Lawrence Livermore National Laboratory 
Lawrence Livermore National Security, LLC, Livermore, California 94551
LLNL-AR-638895

Second Five-Year Review Report for the
Building 854 Operable Unit at
Lawrence Livermore National Laboratory Site 300

Figure 7. Ground water potentiometric surface map for the Tnbs₁/Tnsc₀ hydrostratigraphic unit, including hydraulic capture zones.

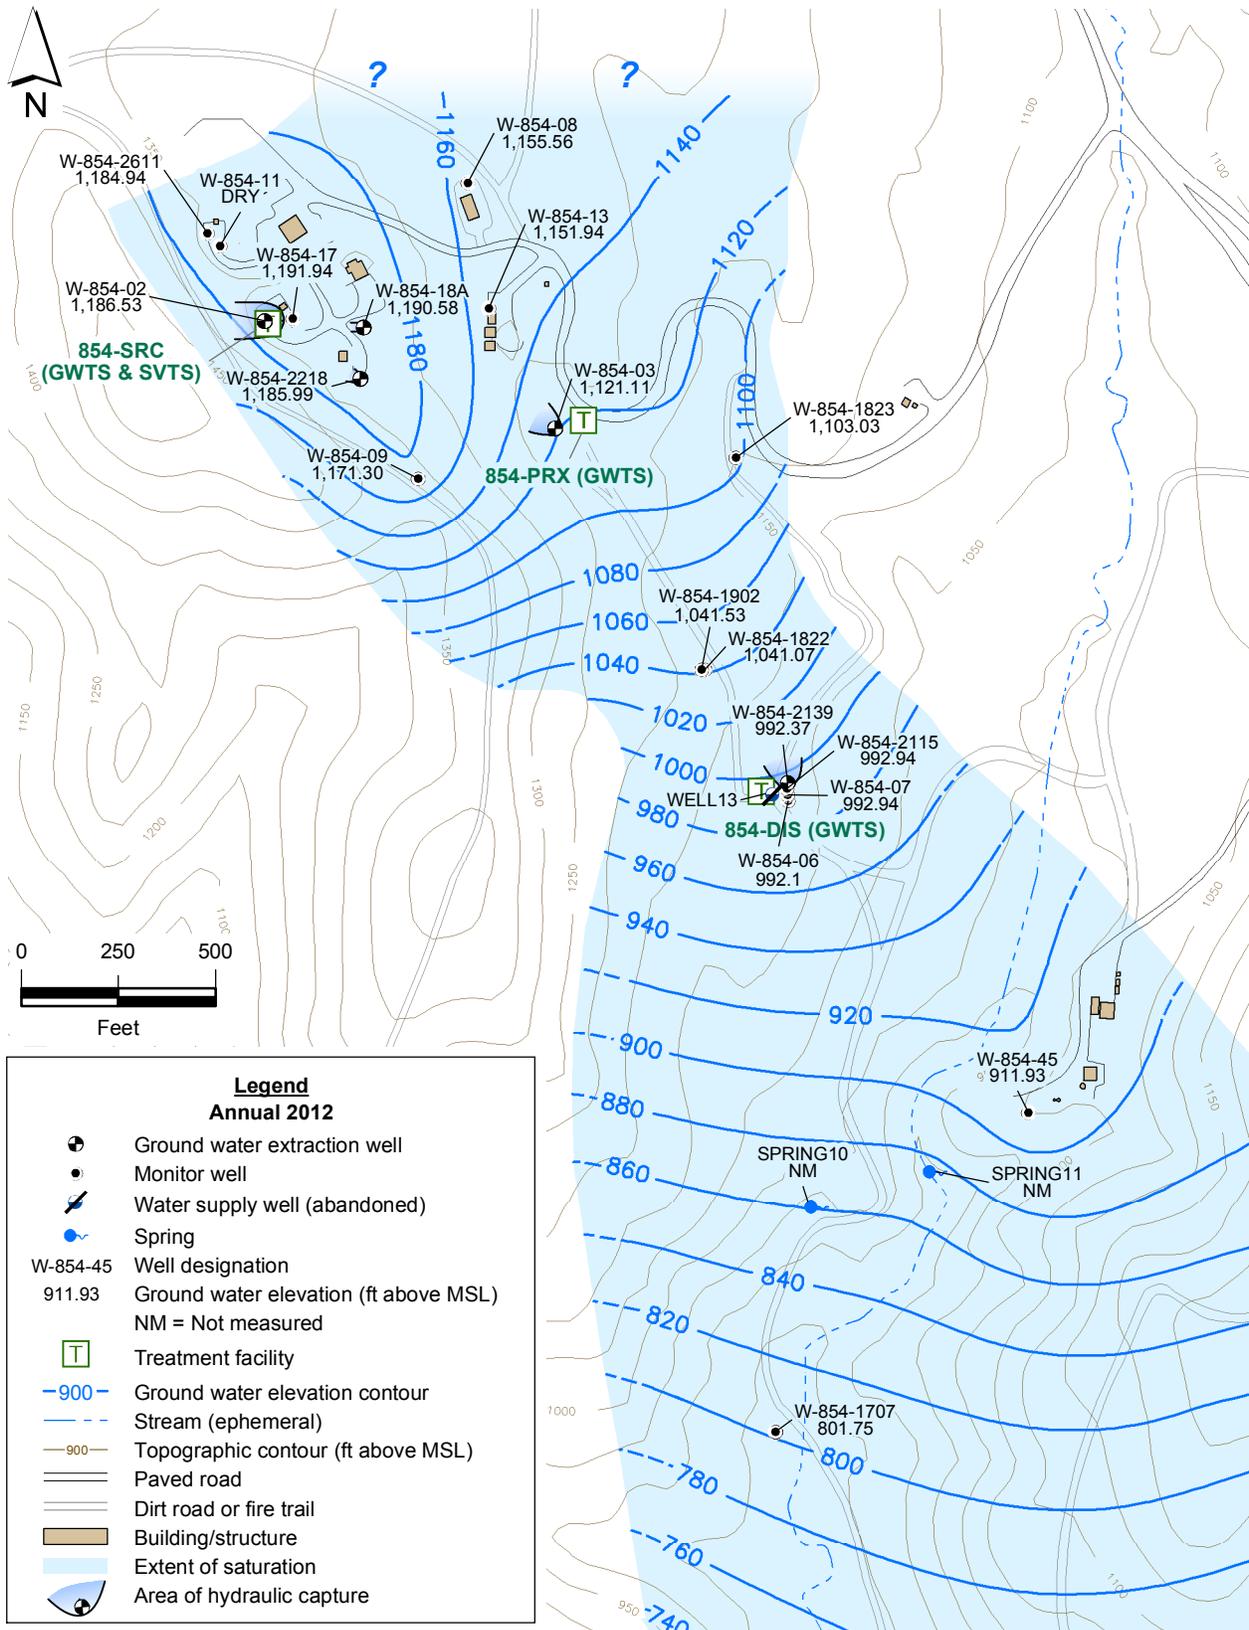
7. **Page 40, Section 6.4.2.3. Capture Zone Analysis:** The last sentence of this section states that the hydraulic capture zones shown on Figure 7 are also shown on Figures 14 and 19. However, Figures 14 and 19 do not show any hydraulic capture zones. The 5-YR Review Report should be revised to show the hydraulic capture zones on the referenced figures.

Response: The references to hydraulic capture zones being shown on Figures 14 and 19 in Section 6.4.2.3 were made in error. Hydraulic capture zones are shown on Figures 7, 15, and 16. The text in Section 6.4.2.3 was revised to reference the correct figures.

Figure 14. Comparison of the existing extraction wells and the distribution of perchlorate in ground water in the Tnbs₁/Tnsc₀ hydrostratigraphic unit in the second semester 2007 and the second semester 2012.

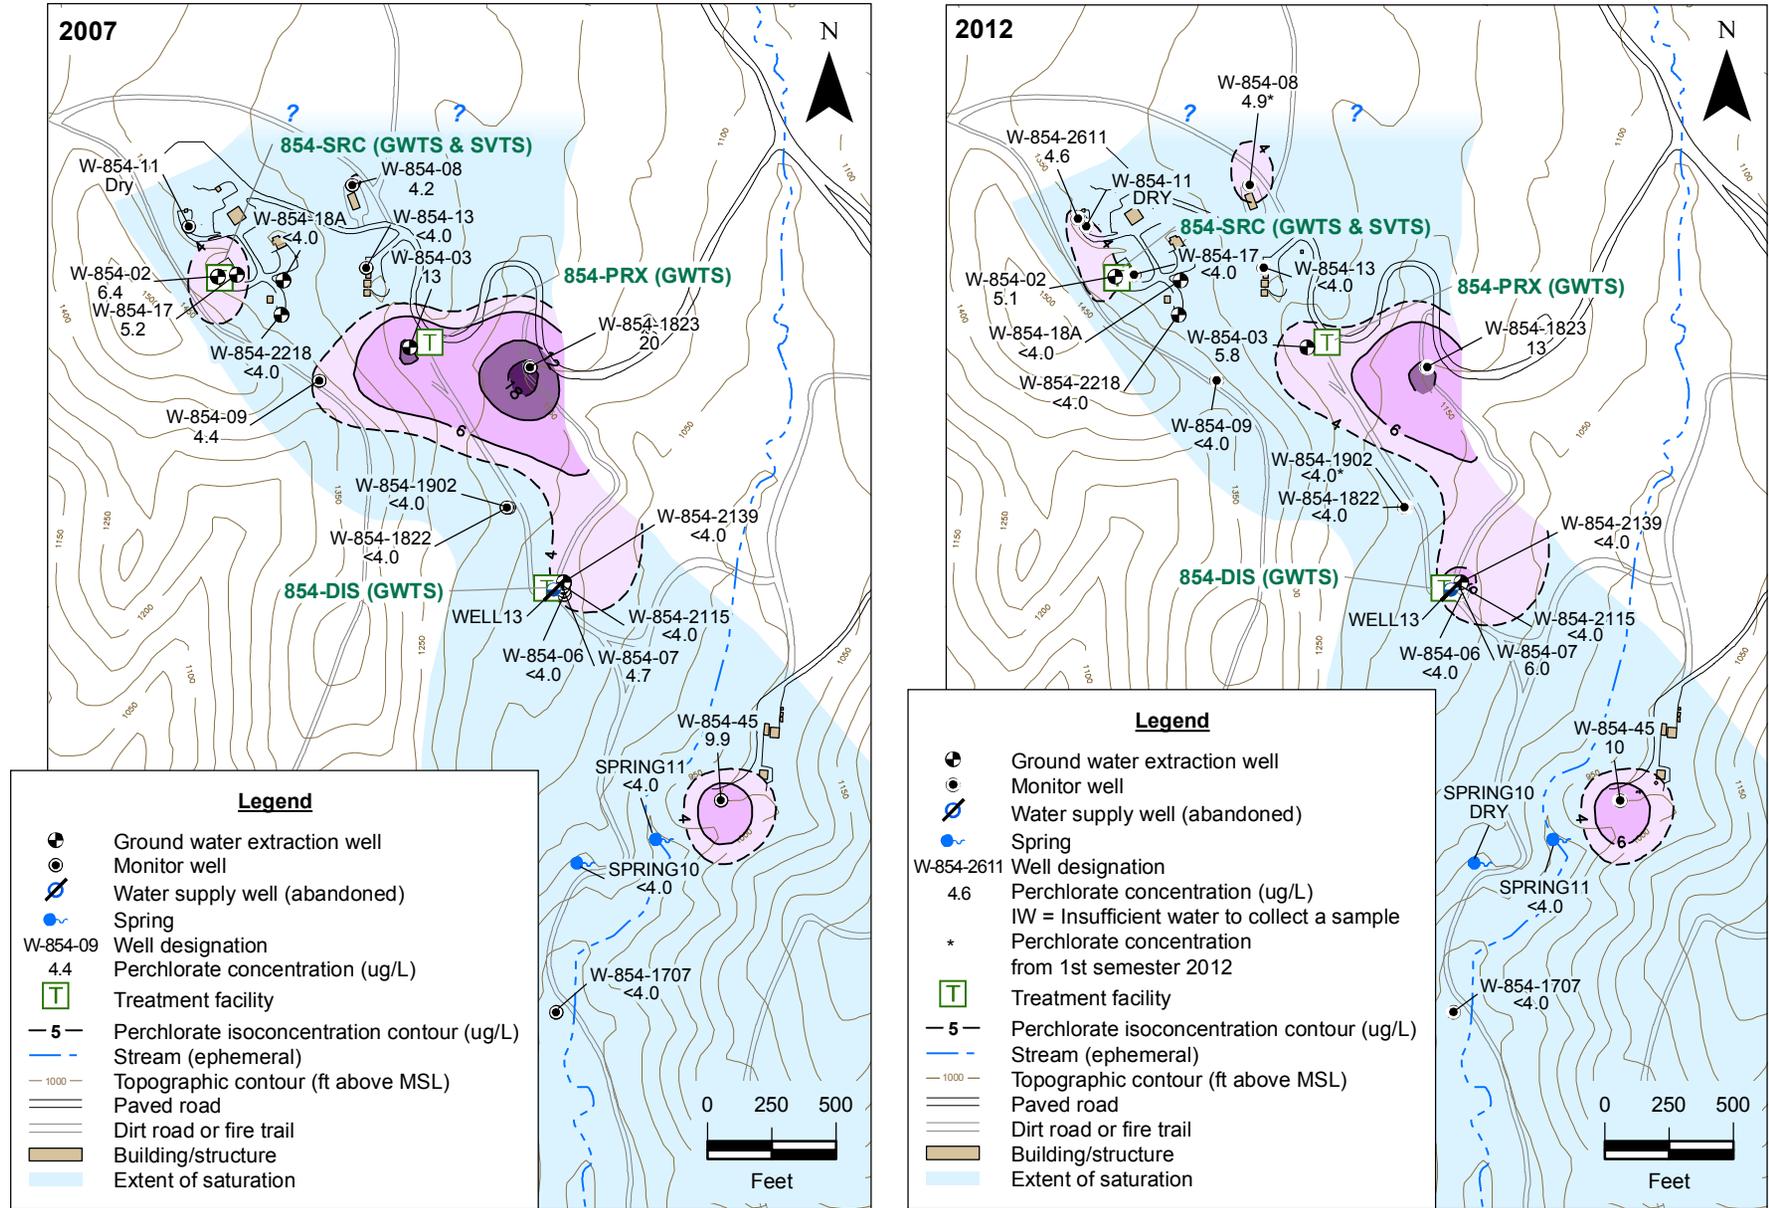
4a. The current remedy for the perchlorate plume around monitoring well W-854-45, located outside the zones of influence of the existing GWTSs, is monitoring and reporting. Based on the plume depicted on Figure 14 for concentrations in 2007 and 2012, the size of the plume has not changed. DOE recommended continued monitoring for perchlorate concentrations in this well during the 2008 Five-Year Review and stated that if concentrations persisted above the maximum contaminant level (MCL) of 6 µg/L, discussions for *in situ* remedial technologies for perchlorate in the immediate vicinity of this well would be initiated. In this 2013 Five-Year Review (i.e. 5-YR Review Report), DOE is making the same recommendation. Analytical data for perchlorate collected from monitoring well W-854-45 over the past several years show that the perchlorate concentrations in this well have for the most part been stable above the MCL or increasing. Therefore, DOE needs to move forward and initiate evaluation of remedial alternatives for perchlorate in the area around W-854-45.

4b. Figure 14 shows that the central perchlorate plume is attenuating. However, except for the decrease in concentration in monitoring well W-854-1823, there is no data to support this interpretation. Regional Water Board staff note that the

Response: In addition to the decreasing perchlorate concentrations in monitor well W-854-1823 over time (Figure 18 and slides 31 and 32 of attached presentation [Attachment C-2]), the perchlorate plume is limited by the extent of saturation (Figures 14 and 16, and slide 11 in attached presentation), and perchlorate concentrations have also been decreasing or have never been detected in monitor wells located downgradient (south) of W-854-1823 (Slides 31, 32, 39, and 40 in attached presentation) including:

Data from these wells support the interpretation that the 2007 20 µg/L perchlorate concentration is not migrating to the south of well W-854-1823. Also, the groundwater flow direction in the vicinity of well W-854-1823 is to the southeast where the plume is limited by the extent of saturation (Figure 7 and slide 11 in attached presentation).

Figure 15. Map showing total VOC isoconcentration contours for the Tnbs₁/Tnsc₀ hydrostratigraphic unit.

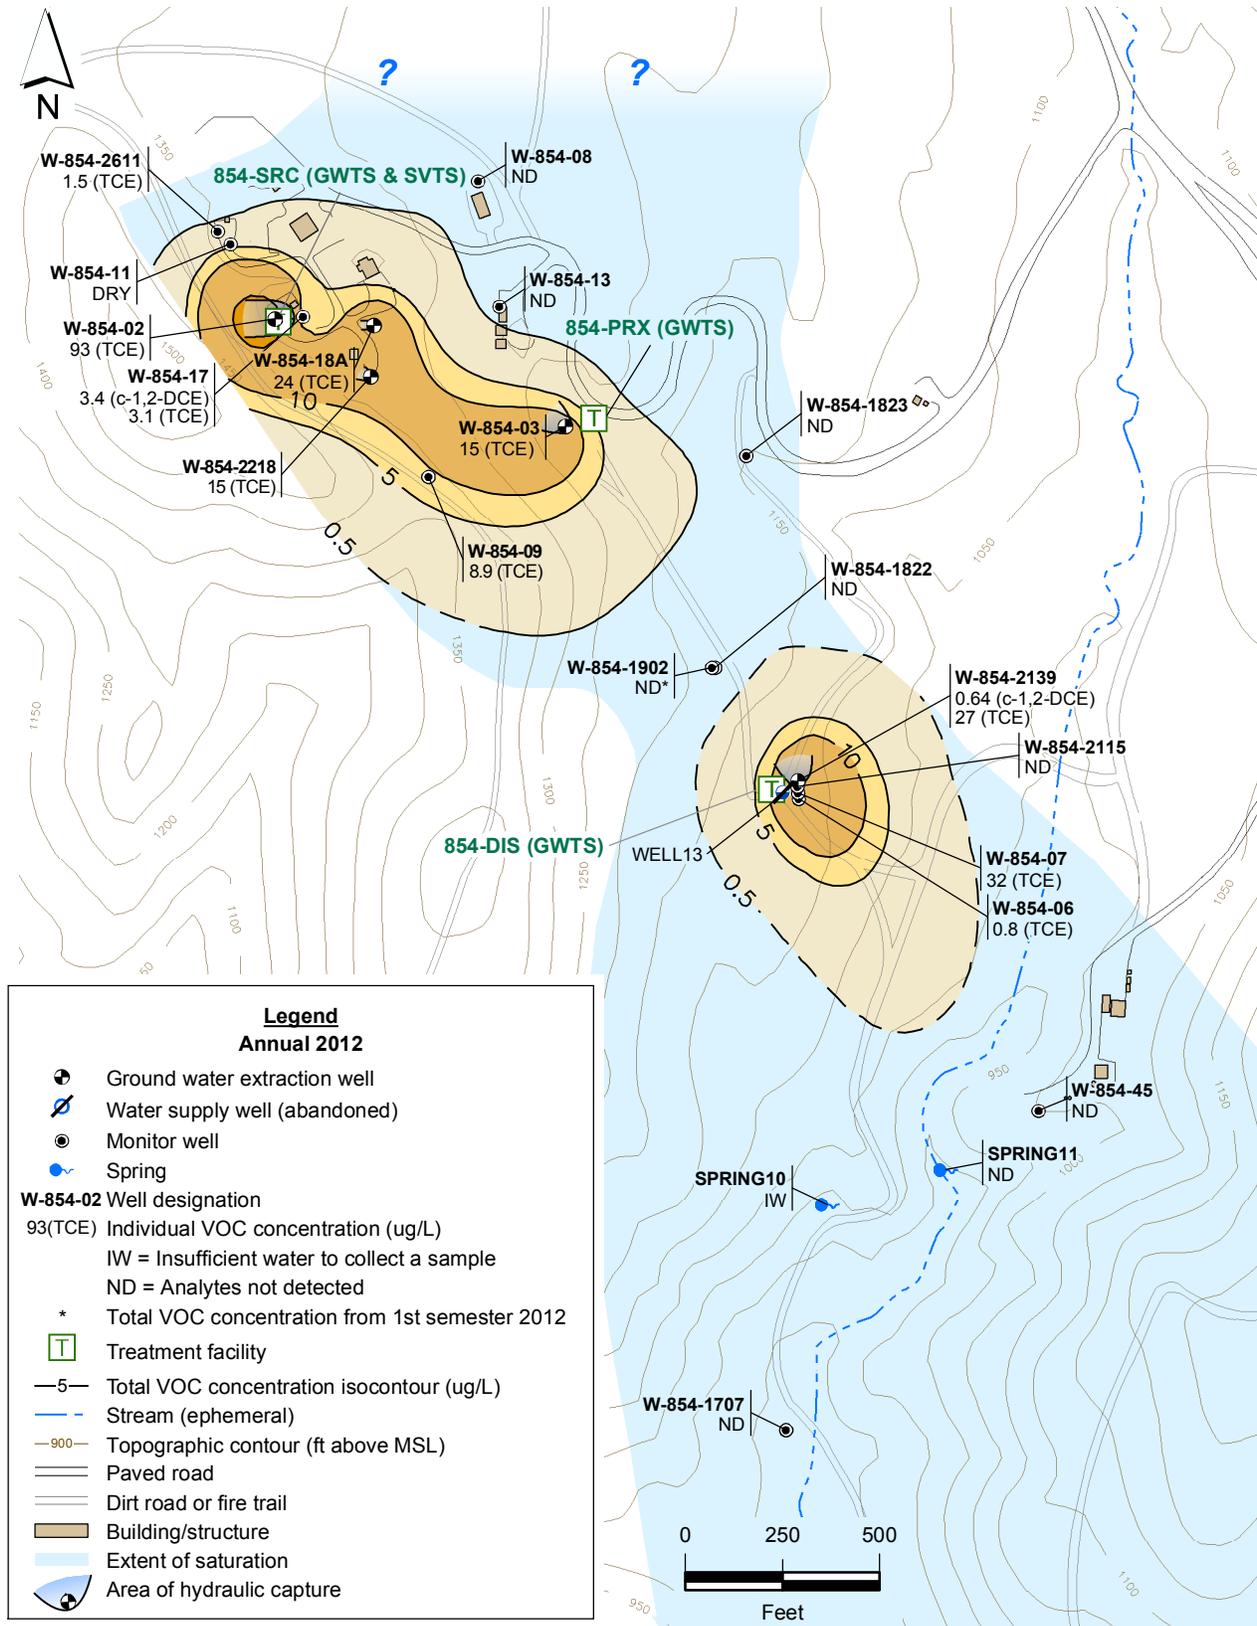
3. The existing groundwater monitoring network at the Building 854 OU is inadequate. There are no groundwater monitoring wells located to the west and south-west of the VOC (volatile organic compound) plumes (depicted in Figures 13 and 15) and outside the influence of the hydraulic capture zones of the GWTSs (ground water treatment systems), to verify that the VOC plumes are not migrating to the west and south-west portions of the site, and to confirm the areal extent of the VOC plumes in these portions of the site. DOE needs to install additional groundwater monitoring wells in the western and south-western portions of the site to fully delineate the VOC plumes and to verify that the plumes are hydraulically contained.
